Defining Reference equalizer for TDECQ with DFE for comment #226

Haiyun Xin, Guangcan Mi, Youxi Lin
Huawei Technologies Co., Ltd

Proposed change

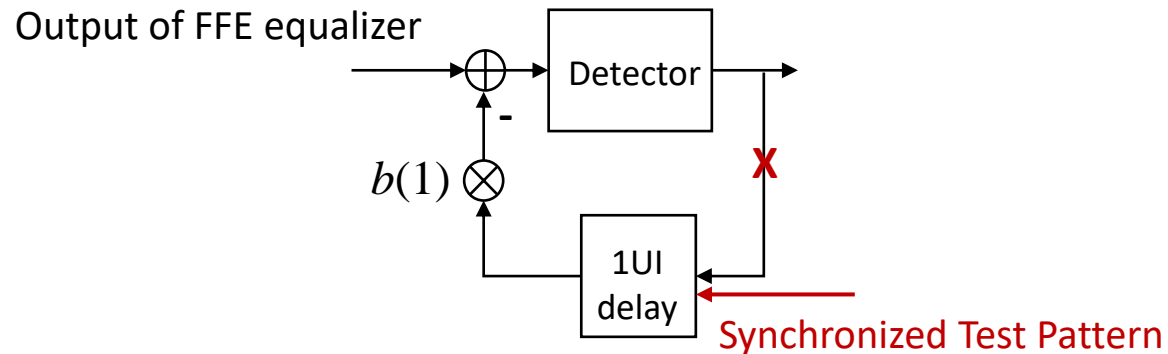
To maintain DC gain =1

- Both $w(i)$ and $b(1)$ apply to $OMA/2$
- FFE limit are applied to the normalized weight, i.e., $w(i)/w(0)$,
- However, DFE limit is not a normalized value.
- No need to call out normalization to $OMA/2$, in fact it is not a normalization, it is the definition of coefficient.

$$\sum_{i=-3}^{11} w(i) - b(1) = 1$$

Figure 180-8 – Illustration of the TDECQ measurement

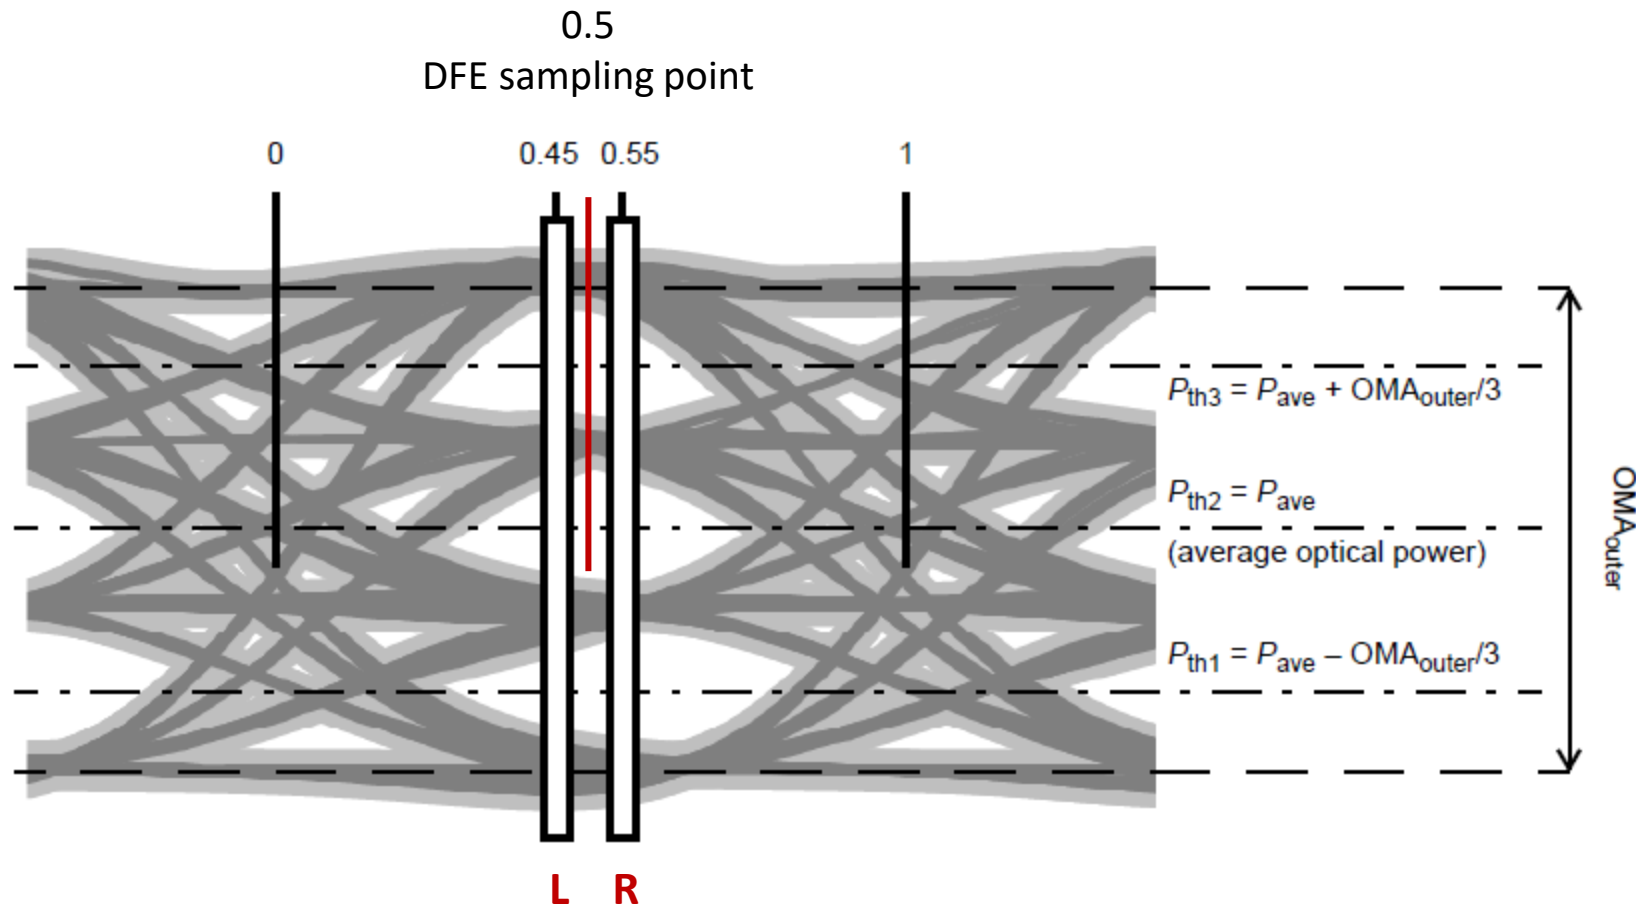
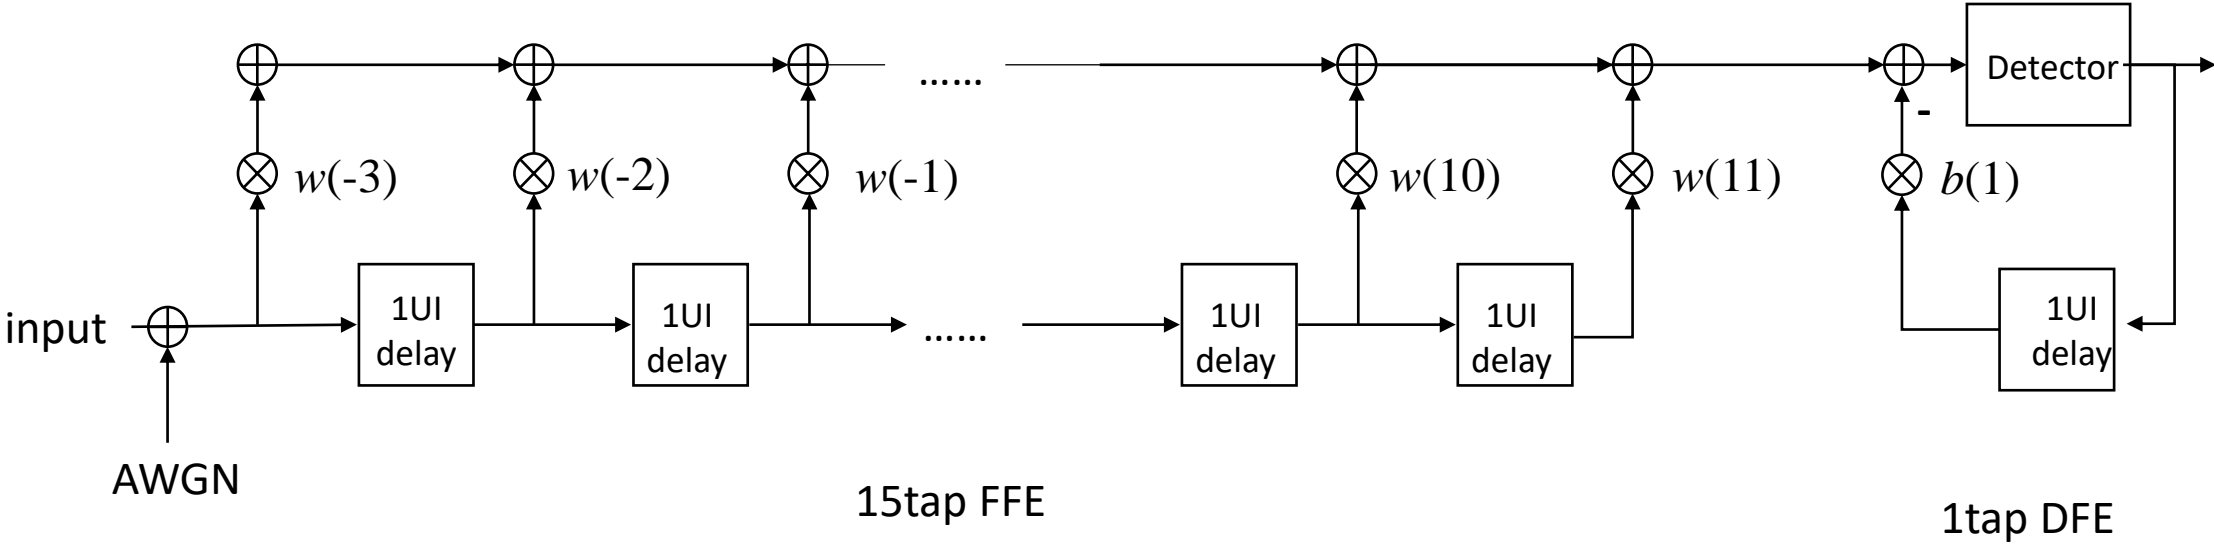
Propose to Add Figure 180-8 TDECQ conformance test block diagram

Propose to Add Figure 180-9 Illustration of the TDECQ measurement

Propose to Add Figure 180-10 TDECQ reference equalizer functional model (1)

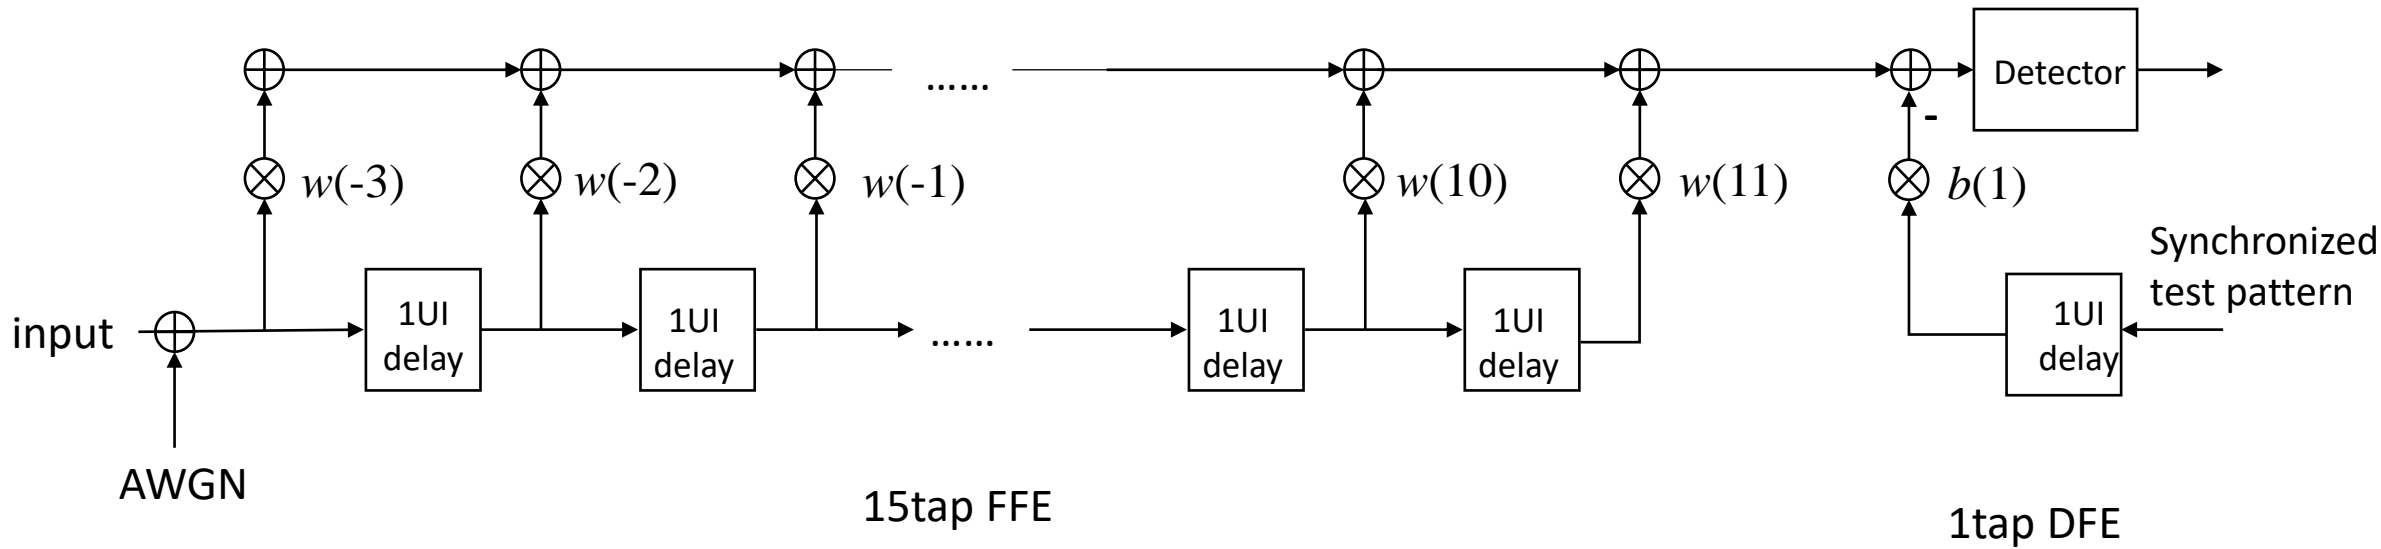
Propose to update calculated SER to reflect error propagation, with changes to the equalizer reference model(2)

$SER_{EP} = SER_0 \times f \rightarrow SER \text{ target}$

$$f = \frac{1}{1 - (P_E - SER_0)}$$

$$P_E = 3/4P$$

Descriptive text with editorial license.
